SCOTT PLANTATION SUBDIVISION, UNITS 6, 7, 8 & 9; AND PLANTATION WEST SUBDIVISION, UNITS 1, 2 & 3

APPLICATION NUMBER 22 DATE December 4, 2003

SCOTT PLANTATION SUBDIVISION, UNITS 6,7,8,& 9; AND PLANTATION WEST SUBDIVISION, UNITS 1,2,& 3

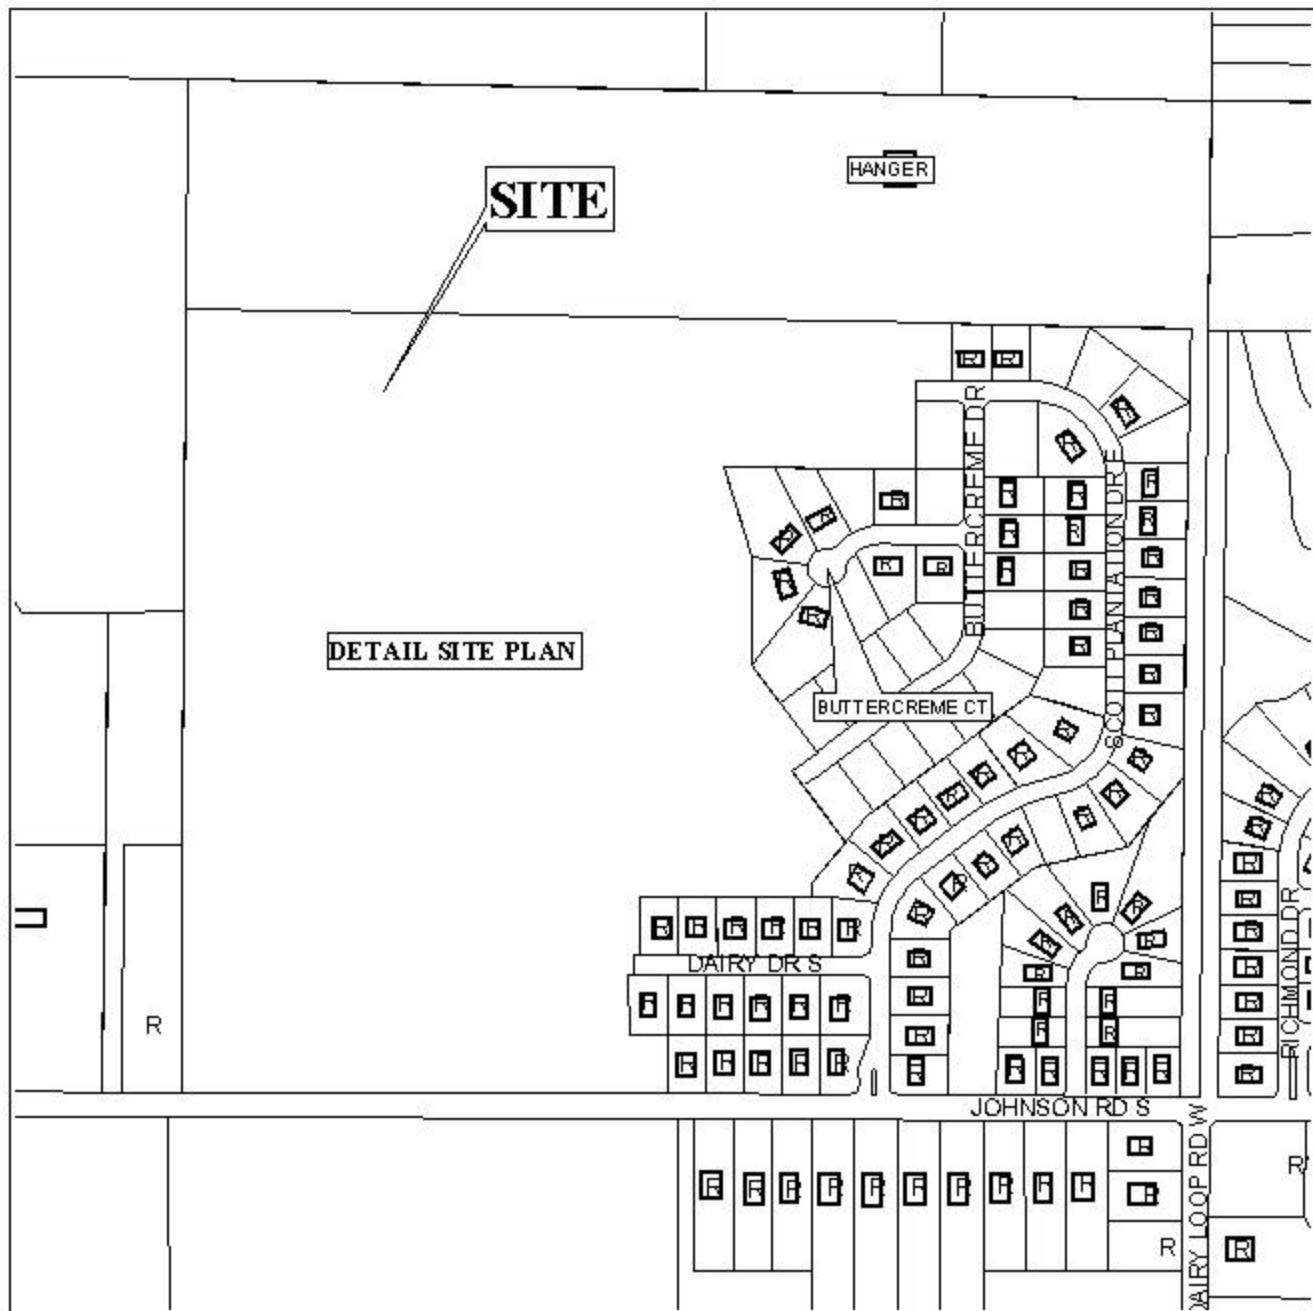
A note should be placed on the final plat stating that lots located on a corner (Lots 24, 27 and 28, **UNIT 1**; Lots 1, 13, 16, 19, 25 and 26, **UNIT 2**; Lots 14 and 23, **UNIT 3**; Lots 6, 7, 13, 25, 26 and 27, **UNIT 6**; Lots 6 and 15, **UNIT 8**; and Lots 6 and 7, **UNIT 9**)) are allowed one curb cut each, with the design, size and location to be approved by County Engineering. Additionally, the proposed layout creates a long "straight a way" and a traffic calming device (traffic circle) should be provided in the area of Lots 10 and 15 of **Unit 1**.

Common/detention areas are shown on the plat, thus the placement of a note on the final plat stating that maintenance of all common/detention areas shall be the responsibility of the property owners, should be required.

As illustrated on the plat, the site also contains wetlands. This area could be considered environmentally sensitive; therefore, the approval of all federal, state and local agencies would be required.

The 25-foot minimum building setback lines are not shown but would be required on the final plat.

With modifications, the plat meets the minimum requirements of the Subdivision Regulations and is recommended for Tentative Approval subject to the following conditions: 1) placement of a note should on the final plat stating that corner lots (Lots 24, 27 and 28, **UNIT 1**; Lots 1, 13, 16, 19, 25 and 26, **UNIT 2**; Lots 14 and 23, **UNIT 3**; Lots 6, 7, 13, 25, 26 and 27, **UNIT 6**; Lots 6 and 15, **UNIT 8**; and Lots 6 and 7, **UNIT 9**) are limited to one curb cut each, with the design, size and location to be approved by County Engineering; 2) the provision of a traffic circle in the area of Lots 10 and 15 of **Unit 1**; 3) all common/detention areas be indicated on the final plat with a note stating that the maintenance thereof is the responsibility of the property owners; 4) that any necessary approvals be obtained from federal, state and local agencies prior to the issuance of any permits; 5) the placement of a note on the final plat stating that any lots which are developed commercially and adjoin residentially developed property must provide a buffer, in compliance with Section V.A.7. of the Subdivision Regulations; and 6) the placement of the 25-foot minimum setback lines on the final plat.
